SECTION 00902

ADDENDUM NO. 2

This addendum modifies the Contract Documents dated March 17, 2020, for the San Lorenzo Valley Water District Lyon and Big Steel Pipelines Improvements Project, and the work shall be accomplished in accordance with such modifications. This Addendum includes two (2) pages plus six (6) attachments (total of 27 pages).

Lyon & Big Steel Zone Pipeline Improvements

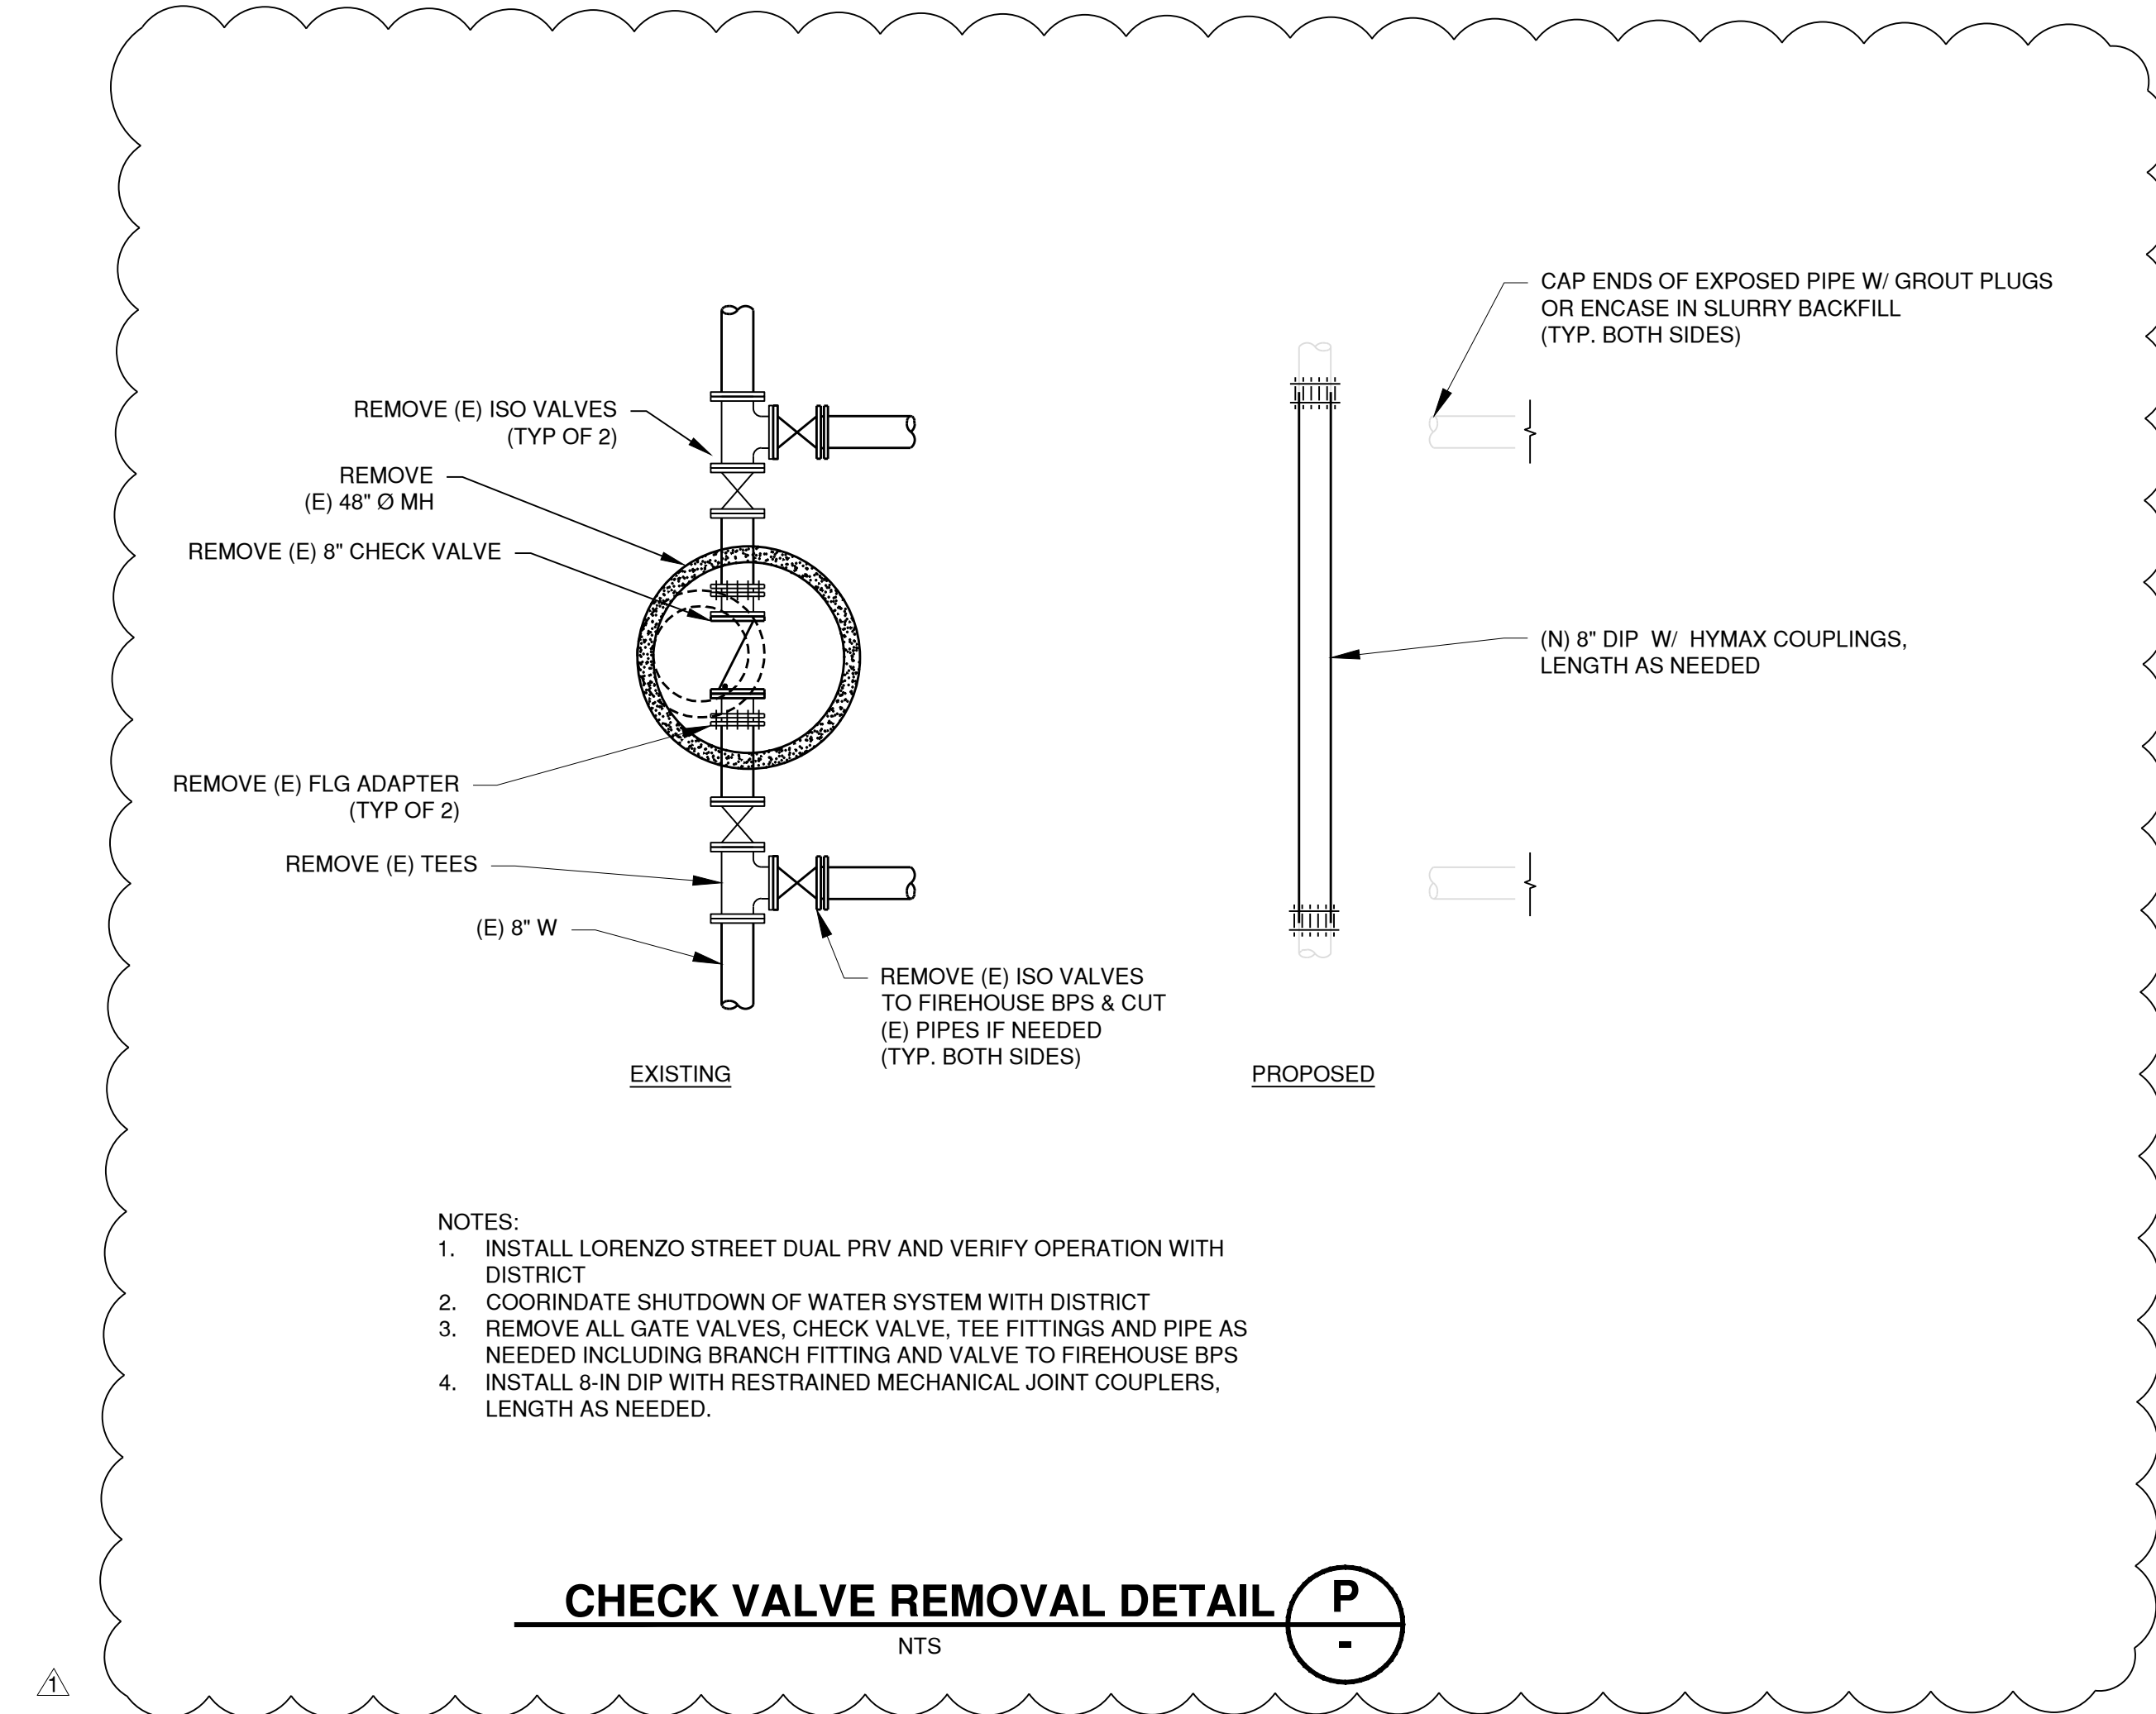
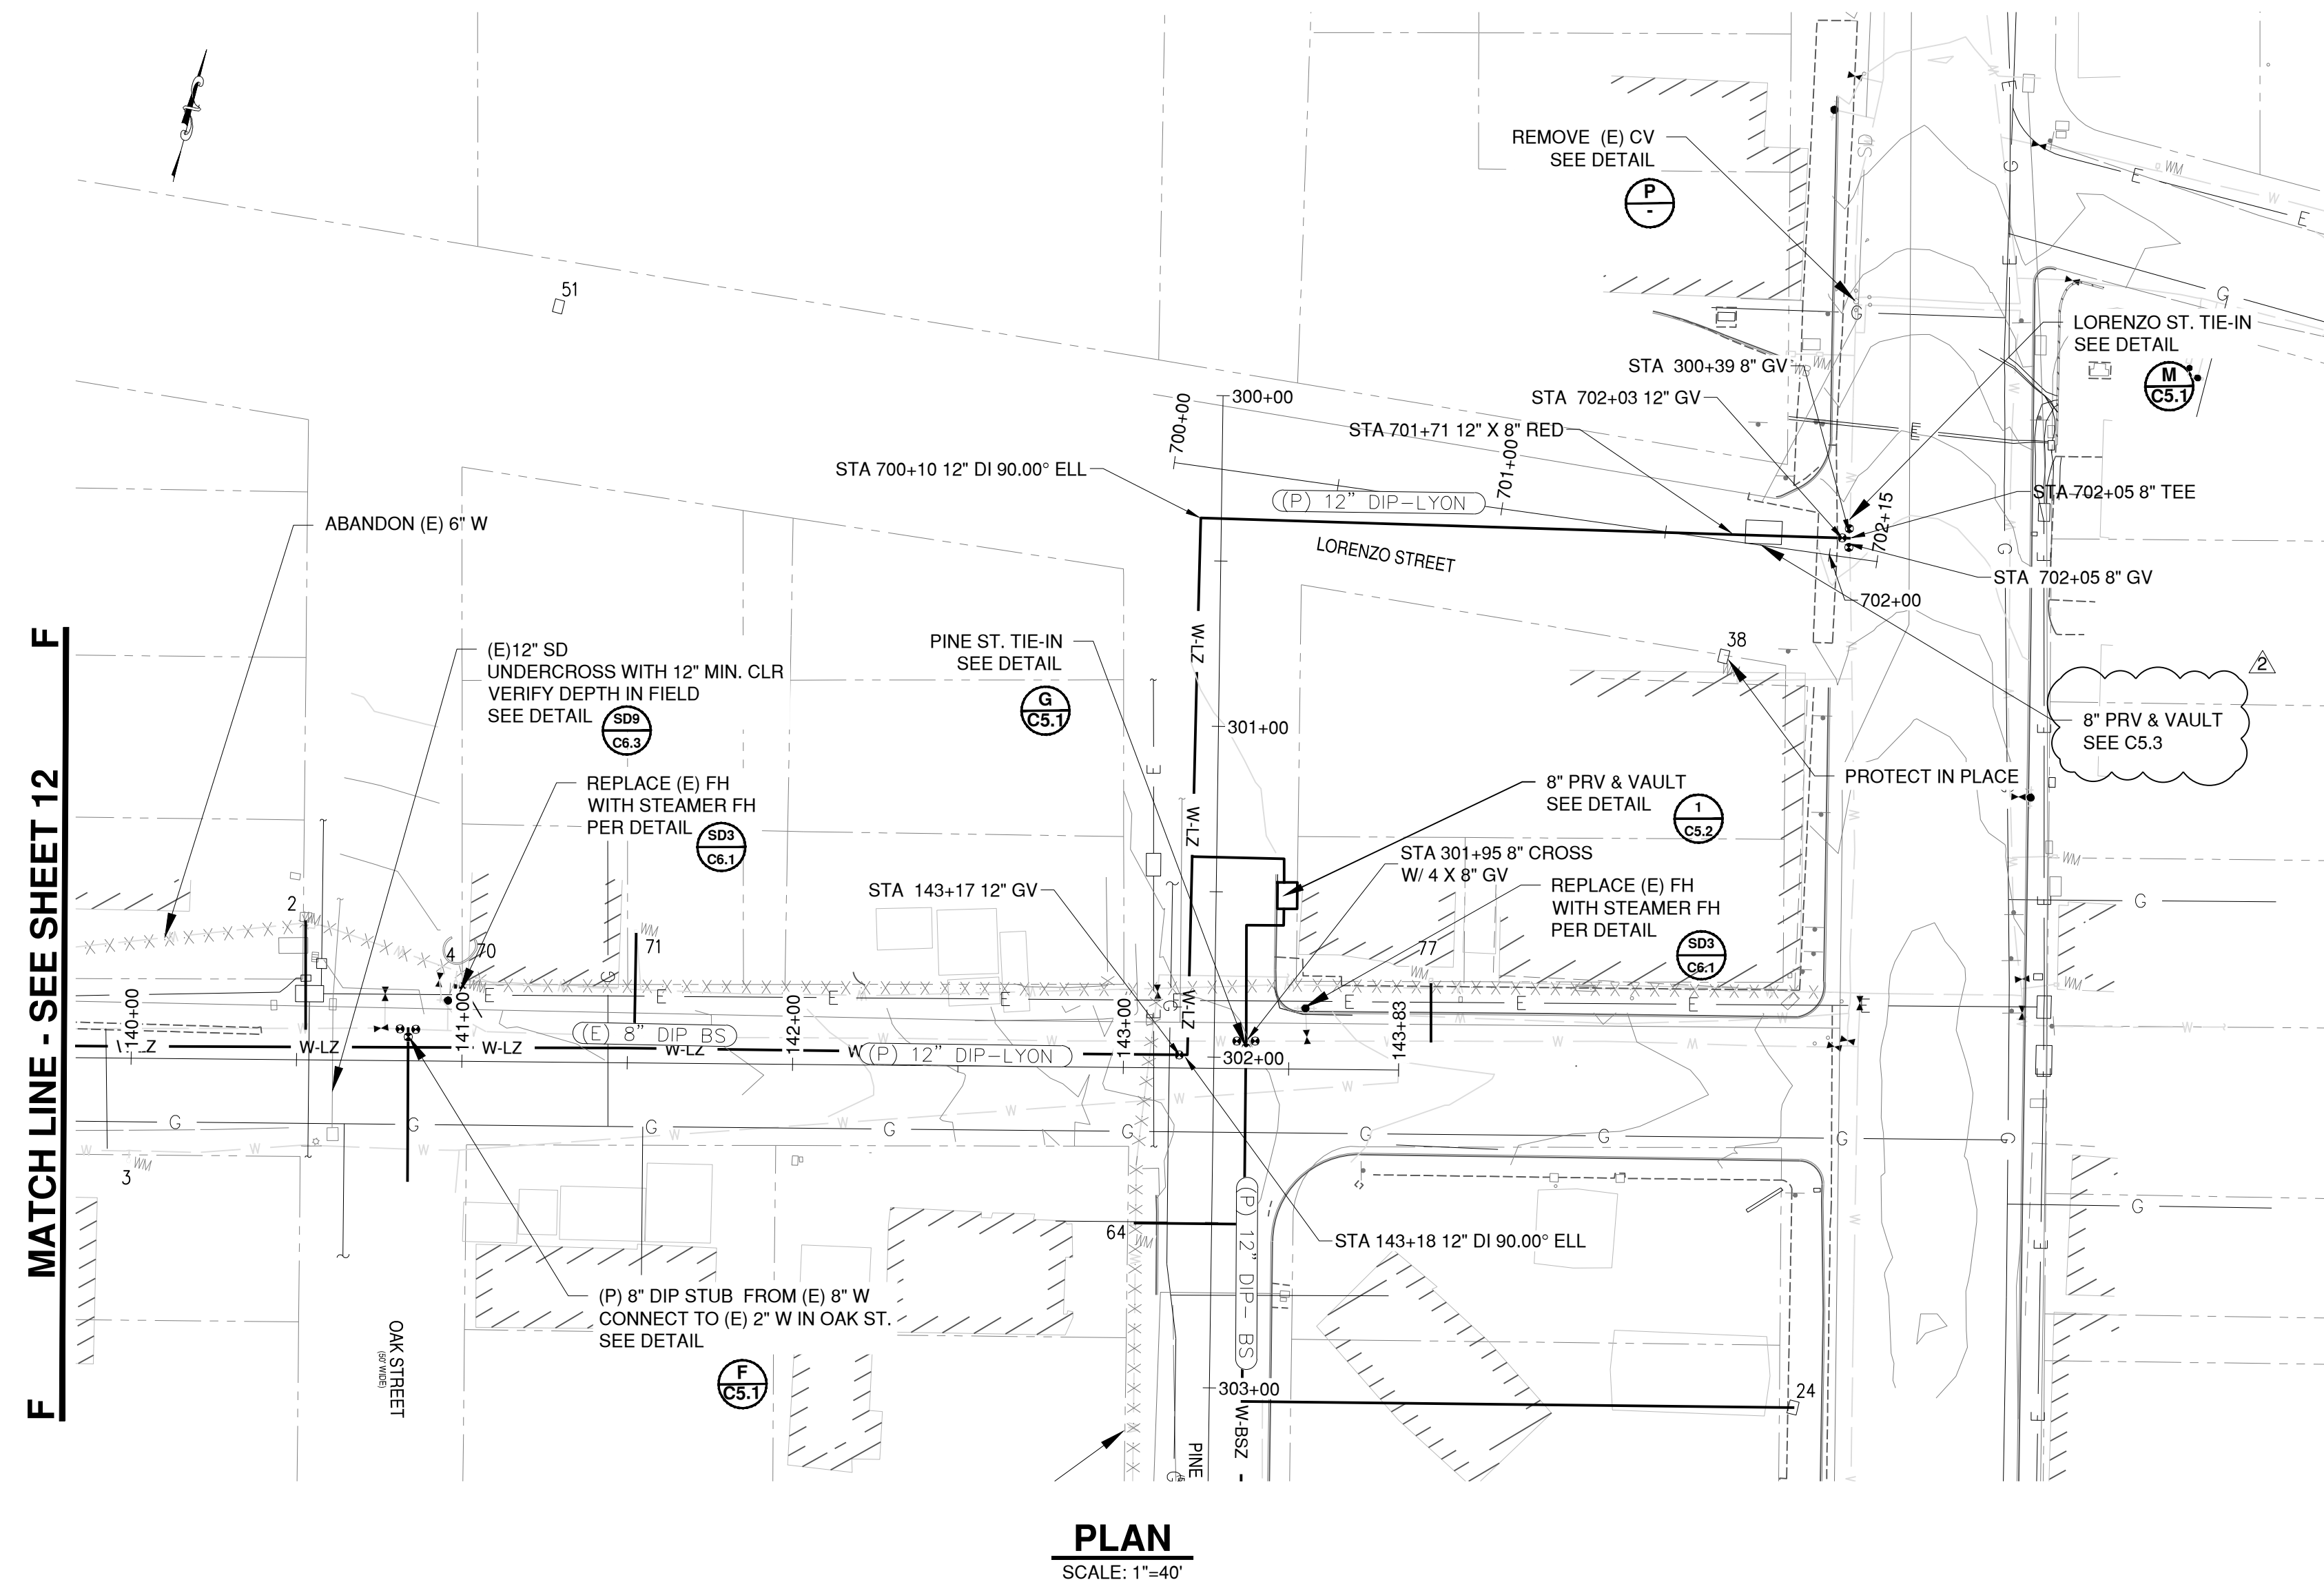
- B. There are two PRV items; item 18, PRV Station in Pine St., and item 19, PRV Station in Lorenzo St. I am only seeing the PRV station in Pine. I do not see a PRV station in Lorenzo. Can you clarify?

- A. Sheet C4.9, Detail P is revised to call out the Lorenzo Street PRV Vault. The changed sheet is attached.
- B. Sheets C6.2 and C6.3 are revised to add the latest Santa Cruz County Encroachment Permit Details. The changed sheets are attached.

- a. Sheet C4.9 is revised to add a callout for the PRV station in Lorenzo Stret. The PRV station is detailed on sheet C5.3.
- C. Please clarify the requirements of Spec Section 32 12 16 ASPHALT PAVING AND SEALS. Are we to HMAC Pave or repave all road surfaces within the public Right of Way, etc., or are we to provide a Slurry Seal? Or both?
